WWW.TEMPLEFORMULARACING.COM

TEMPLE UNIVERSITY

53003 - Shifting Lever

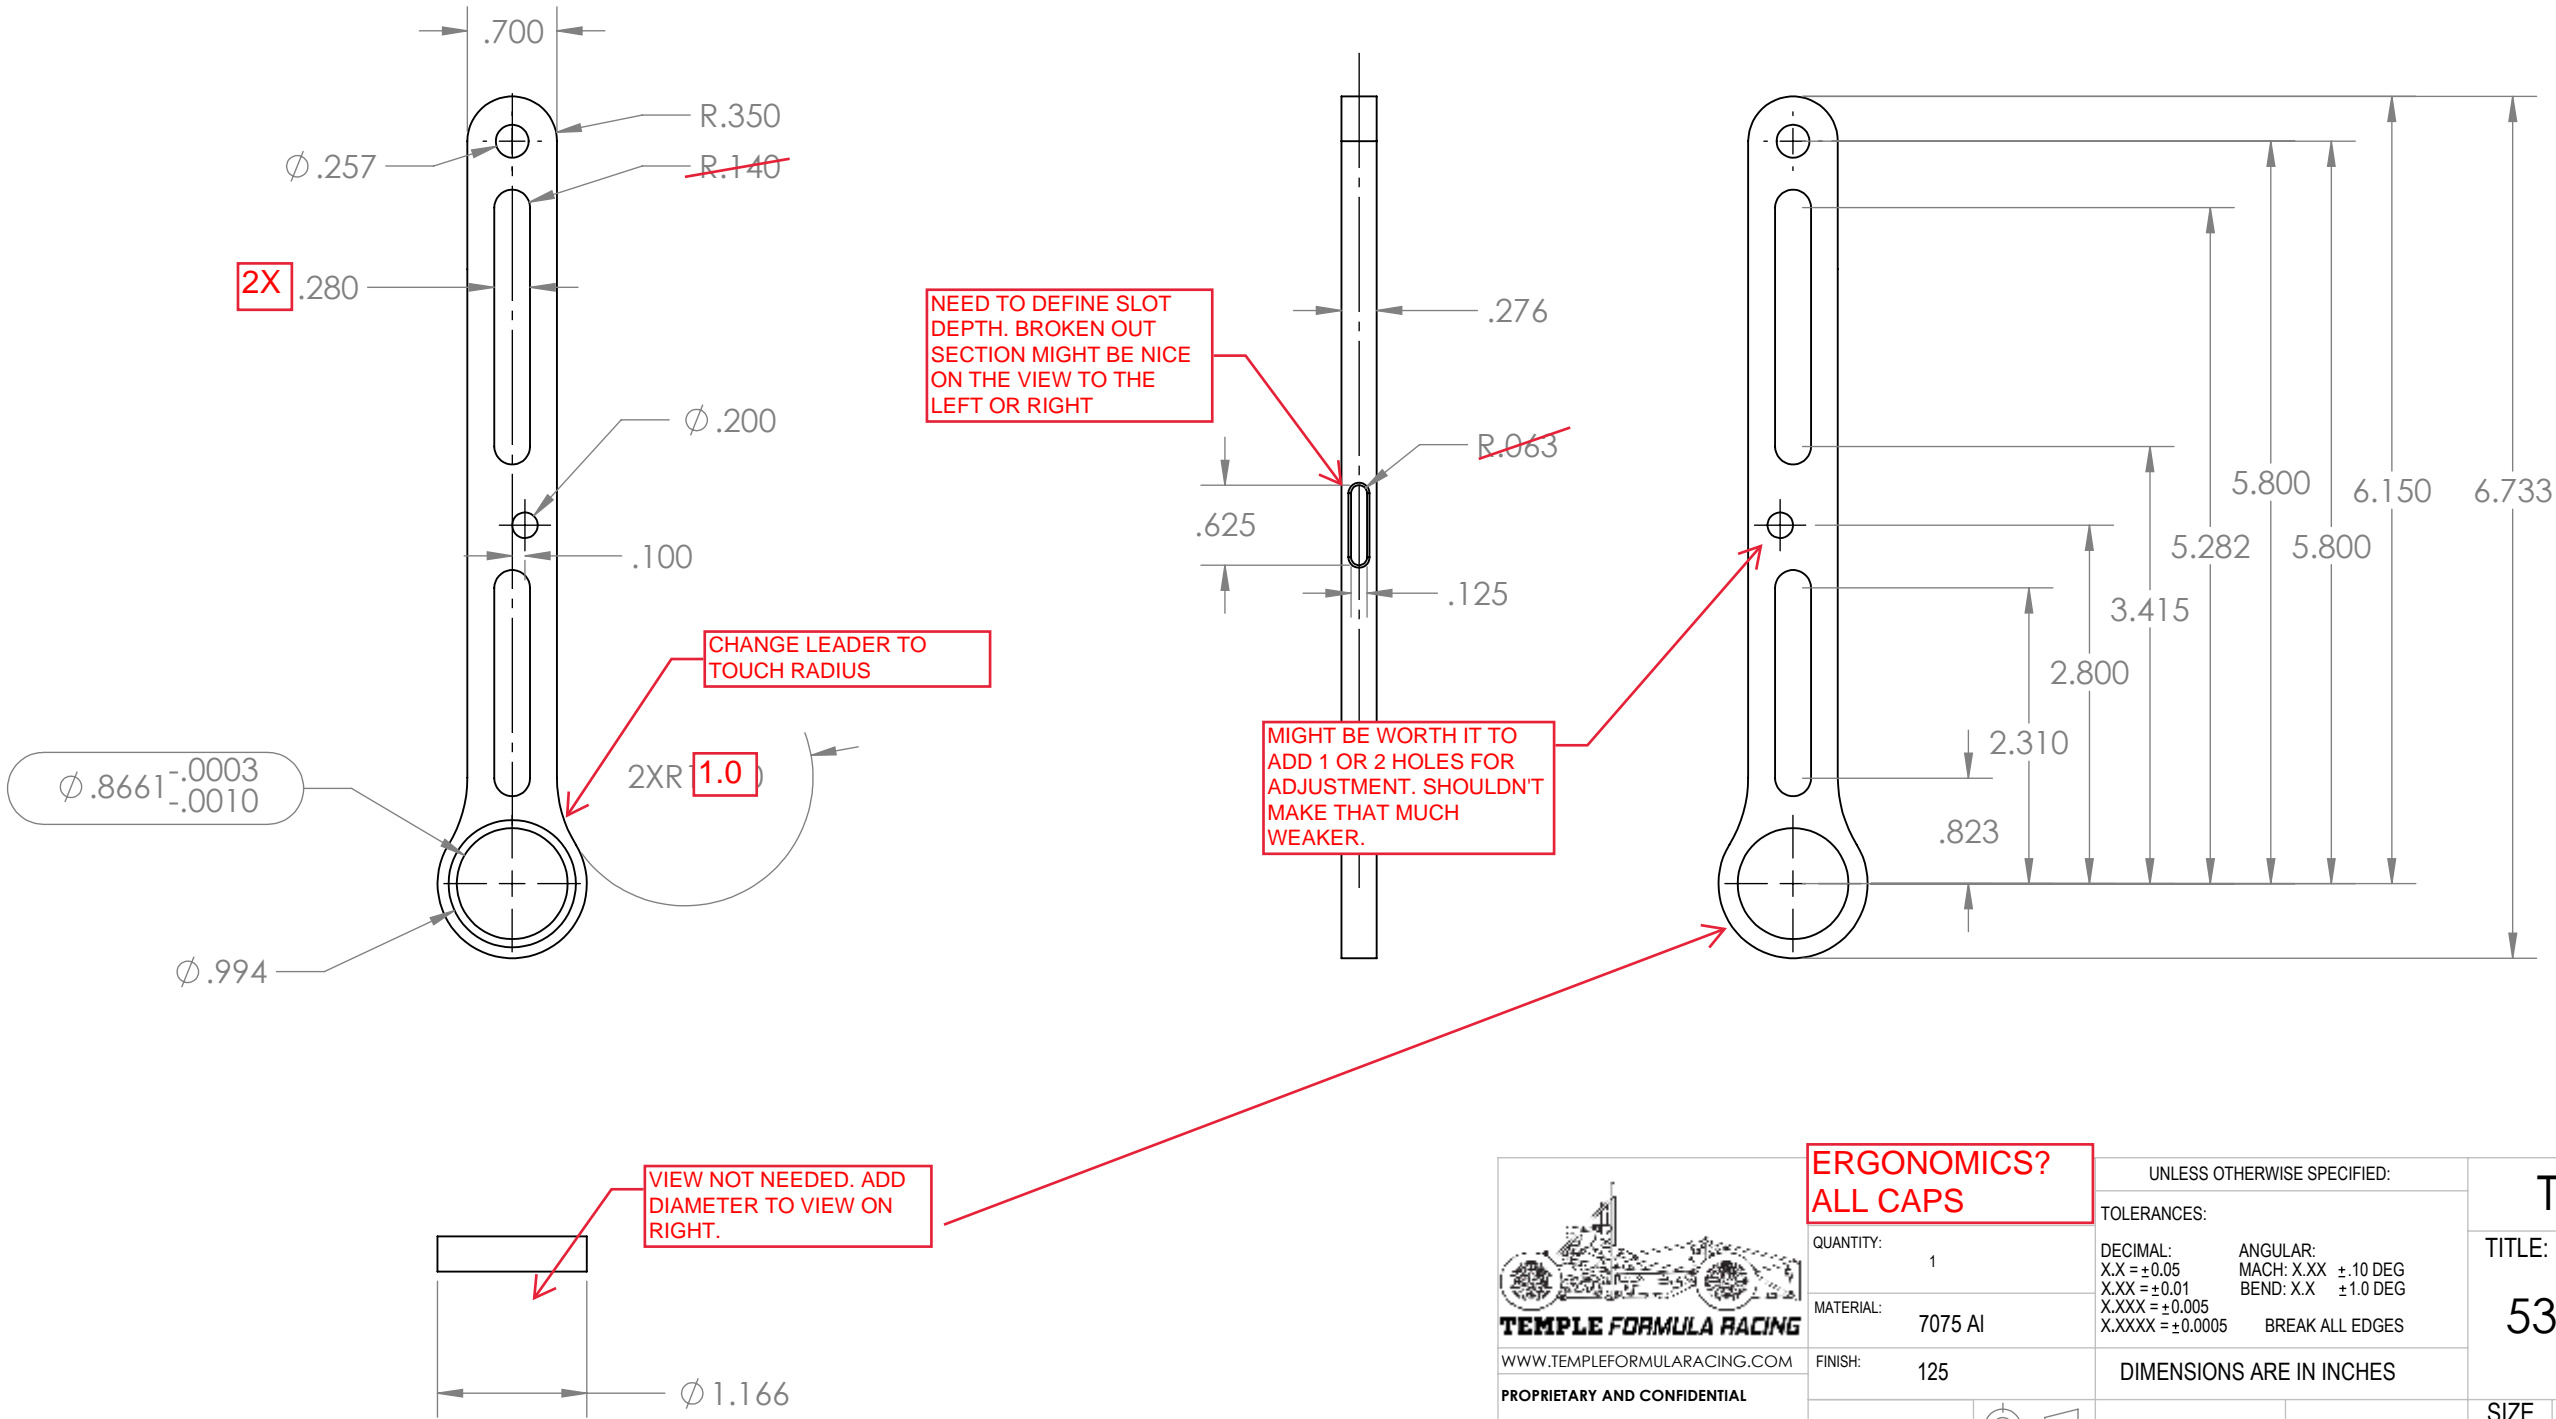
NOTHING WRONG WITH THE 3 UPPER VIEWS BUT THE LEFT AND RIGHT ARE KIND OF REDUNDANT. YOU COULD MAKE BETTER USE OF ONE BY CONVERTING IT TO A SECTINO VIEW.

NEED TO DEFINE SLOT DEPTH. BROKEN OUT SECTION MIGHT BE NICE ON THE VIEW TO THE LEFT OR RIGHT

CHANGE LEADER TO TOUCH RADIUS

MIGHT BE WORTH IT TO ADD 1 OR 2 HOLES FOR ADJUSTMENT. SHOULDN'T MAKE THAT MUCH WEAKER.

VIEW NOT NEEDED. ADD DIAMETER TO VIEW ON RIGHT.

ERGONOMICS?
ALL CAPS
